HOPE CREEK GENERATING STATION  
DOCKET NO. 50-354  
FSAR COMMITMENT STATUS THROUGH AUGUST 1984

ATTACHMENT I  
HOPE CREEK GENERATING STATION  
FSAR COMMITMENT STATUS THROUGH AUGUST 1984

QUESTION 220.21 (SECTION 3.7.2)

FIGURE 210.21-31  
 RESPONSE SPECTRA COMPARISON,  
 AUXILIARY BUILDING AT ELEV. 54' -0",  
 VERTICAL, SSE, 2% DAMPING

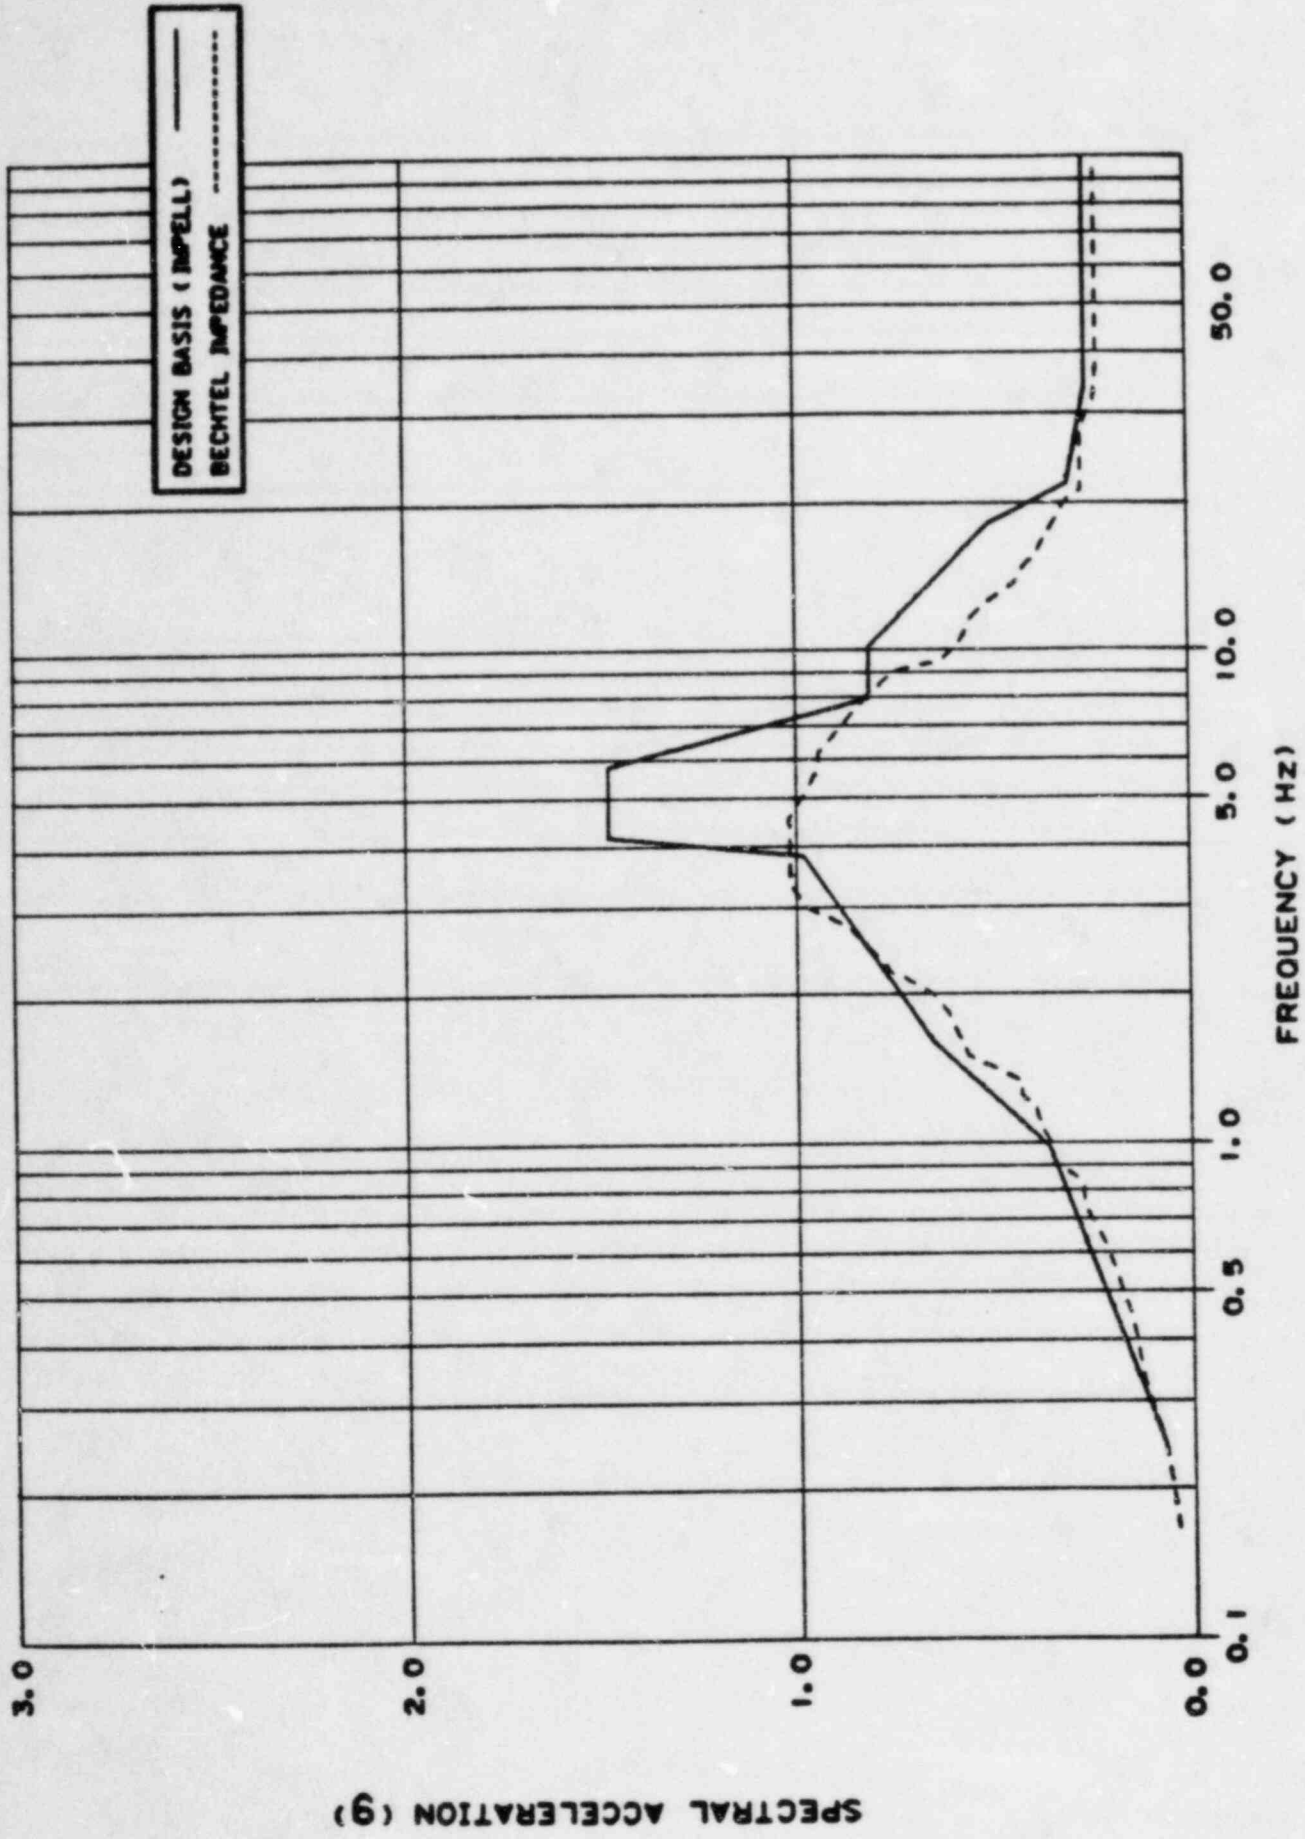
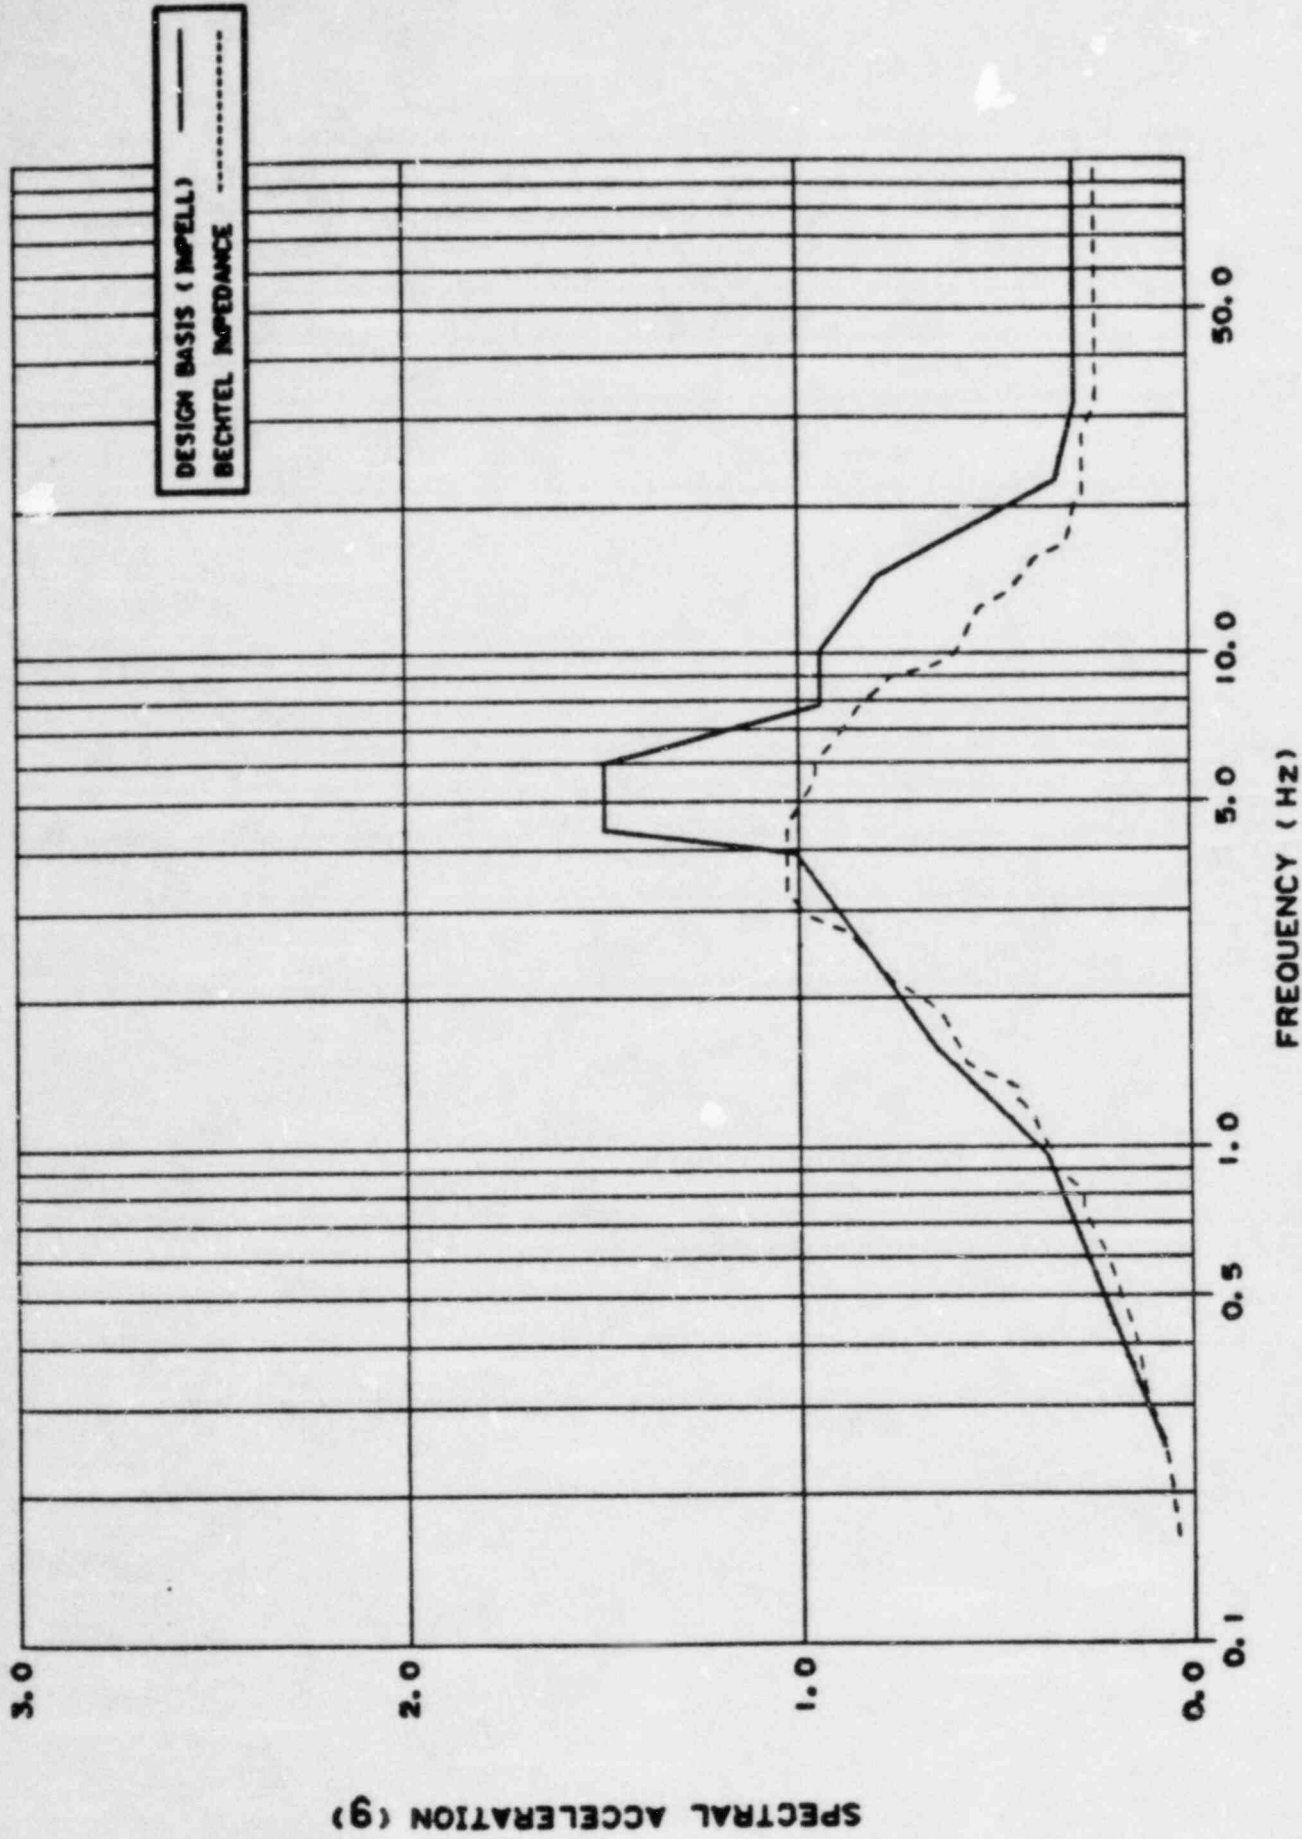
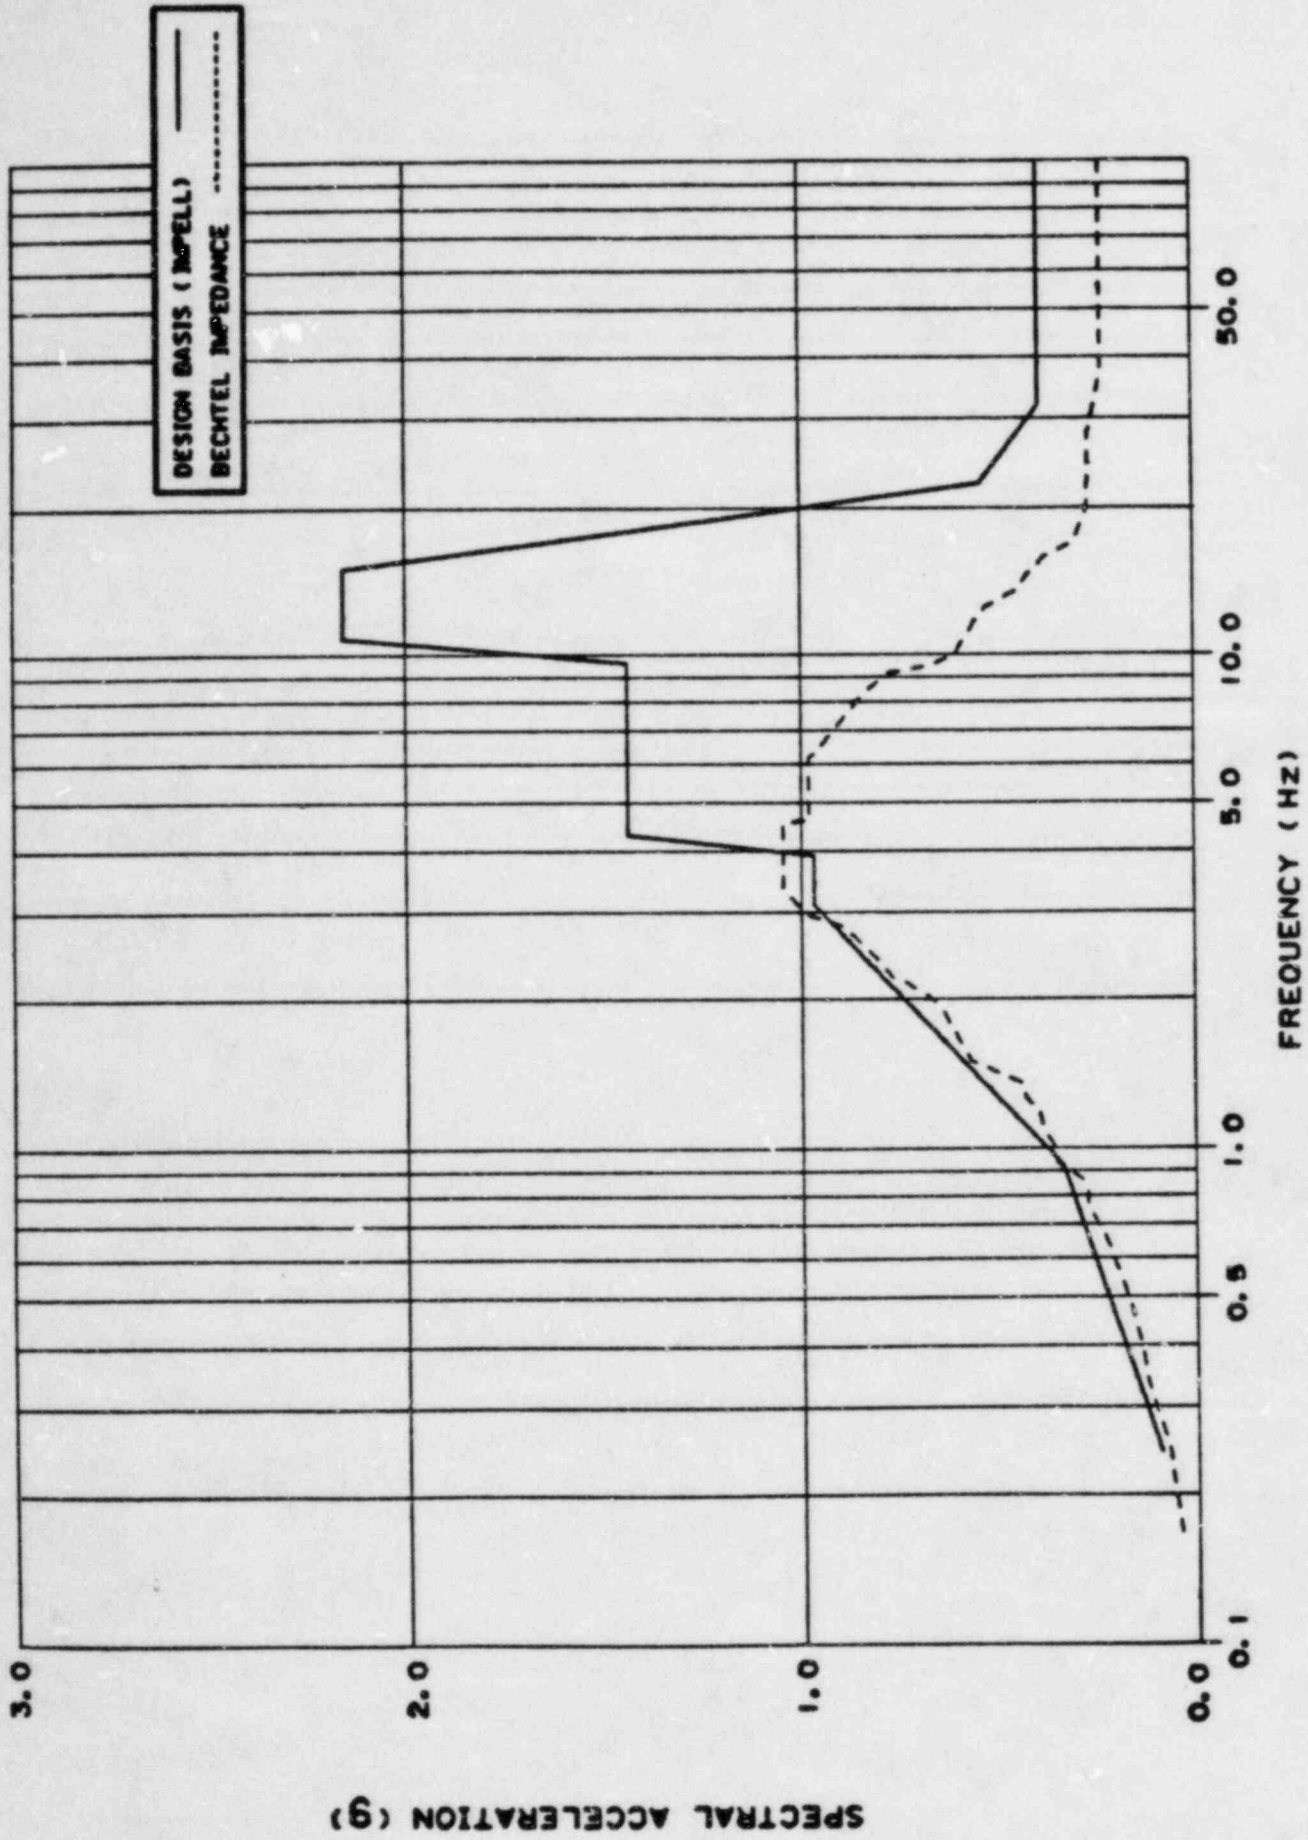
The Hope Creek soil-structure interaction analysis is performed by applying a specified earthquake input motion at the base of the finite-element model. The base level input motion is generated through a deconvolution analysis. The applicable SRP criteria for soil-structure interaction analysis require that both the half-space and finite-element approaches should be considered. (For details refer to SRP 3.7.2-11.4). Public Service should perform necessary analyses to demonstrate conformance to the criteria.

Figures 220.21-1 through 220.21-54 show a comparison of the 2 percent damping response spectra obtained from the design basis finite element and the impedance analyses for the reactor building, auxiliary building and the service water intake structure (SWIS).

¶ For the reactor and auxiliary buildings, the peak spectral accelerations obtained from the impedance analysis are generally lower than those obtained from the design basis analysis. However, the impedance analysis response spectra are not completely enveloped by those obtained from the design basis analysis, especially in the frequency range from 1.0 to 3.5 Hz. Also, there are some local exceedances in the higher frequency range, as shown in Figures 220.21-1 through 220.21-36. ¶ For the SWIS (Figures 220.21-37 through 220.21-54), the impedance analysis response spectra are generally enveloped by those obtained from the design basis analysis at elevation 114.0 feet. For other elevations, the impedance analysis spectral accelerations exceed the design basis spectral accelerations in some frequency ranges. These ranges vary approximately between 1.5 and 10.0 Hz.

forces and moments obtained from the impedance analysis exceeded the design basis values at various locations within these buildings. The auxiliary building seismic shear forces and moments obtained from the impedance analysis are less than the design basis shears and moments.

Since the impedance analysis results are not completely enveloped by the design basis finite element analysis results, sampling studies are conducted to confirm the adequacy of the plant design. These sampling studies include an evaluation of the following items:

In all cases, the items reviewed during these sampling studies can accommodate the loads resulting from the impedance analysis. Therefore, the impedance analysis results have no impact on the plant design.
